Service Information Letter

Shimmy Damper Mounting Bracket

Model 208 and 208B with STC10841SC conversion applied.

Figure 1 Shimmy Damper Mount Bracket Assembly

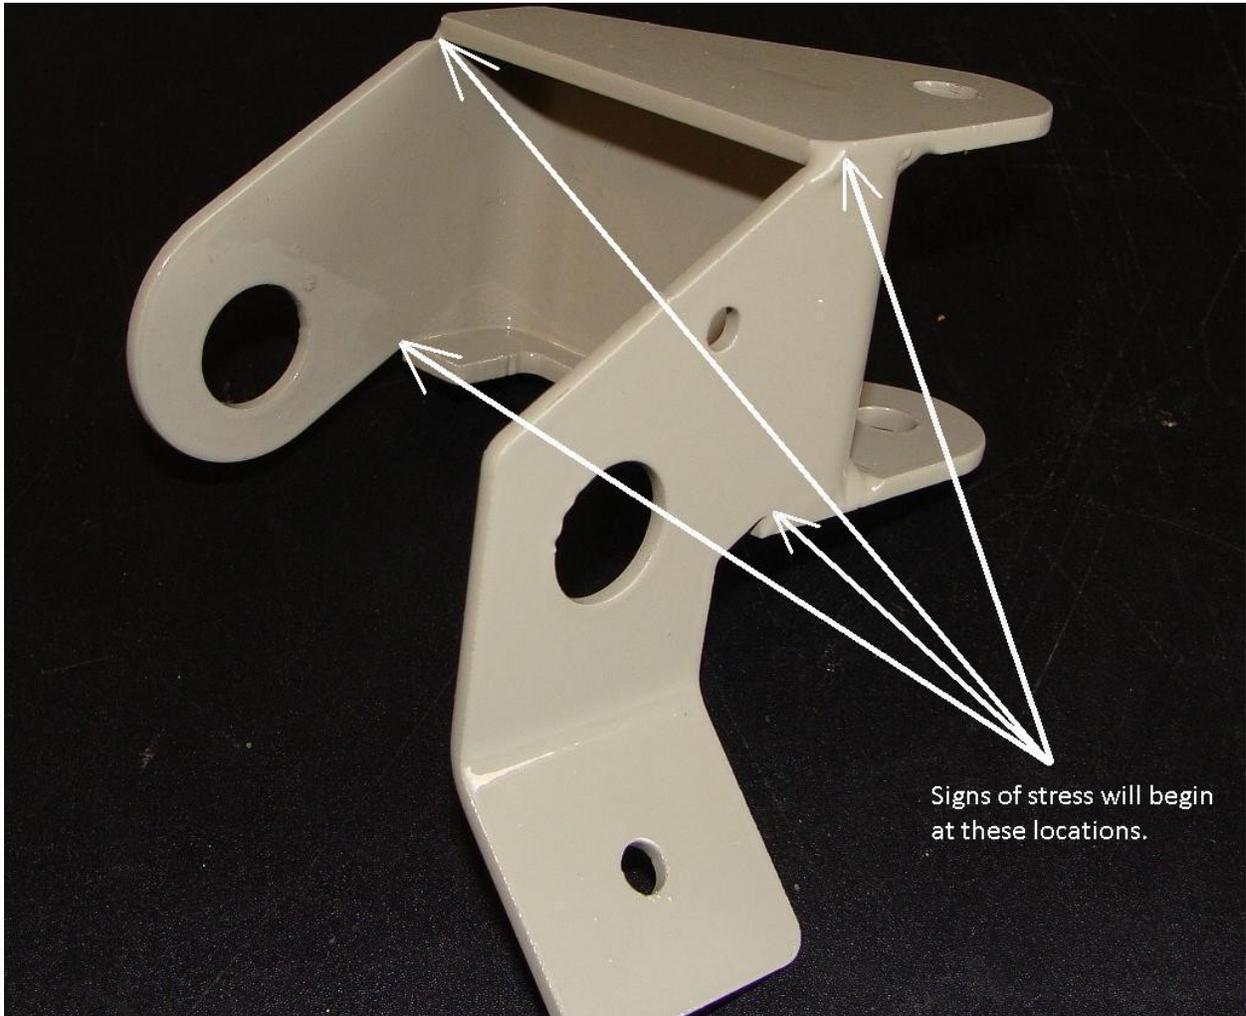
The purpose of this Service Information Letter (SIL) is to inform operators and maintenance technicians of a potential failure in the shimmy damper mounting bracket assembly. Figure 1 shows the stress concentration locations that should be inspected prior to each flight. The new design is in the process of being approved and notification of availability will be made per Service Bulletin No. SB-208-1. Regular preflight inspections of the shimmy damper mounting bracket assembly are essential towards preventing a possible failure.

Over the past 2 years, Supervan Systems Ltd. has noticed that the shimmy damper mounting bracket assembly has shown signs of fatigue. In response to this condition, Supervan Systems Ltd. has designed an improved shimmy damper mounting bracket assembly which will improve the durability of the design. The replacement of this shimmy damper mount bracket assembly will be mandatory.
